**Comments on the
DRAFT ENVIRONMENTAL ASSESSMENT REPORTS and
POTENTIAL CONDITIONS UNDER THE *CANADIAN ENVIRONMENTAL
ASSESSMENT ACT, 2012* for the
BHP CANADA,
CENTRAL RIDGE, and
WEST FLEMIST PASS
EXPLORATION DRILLING PROJECTS**

November 2020

By the NunatuKavut Community Council

Figure 1: Comparing the location of NL offshore exploratory projects with movement of Atlantic salmon smolts.¹³

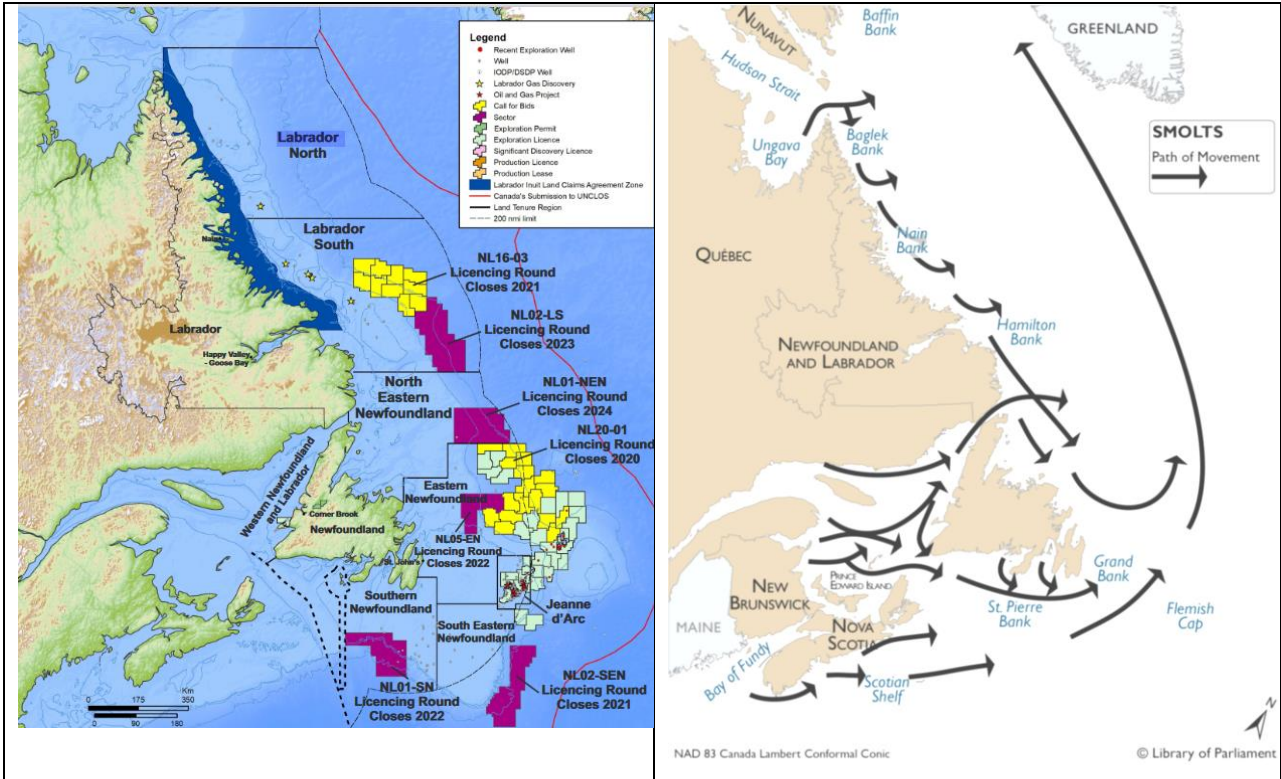
While uncertainty obviously exists, some existing information about salmon migration patterns points to the fact that young salmon leaving natal rivers on the coast of southern Labrador often follow the flow of currents heading south, en route to feeding and overwintering grounds. In so doing, they pass rather directly through offshore development areas in the Orphan Basin and West Flemish Pass, as shown in **Figure 1**, below. Information on smolt movements are referred to in the BHP Canada EIS and West Flemish EIS, along with a map, reproduced on the right side of Figure 1.
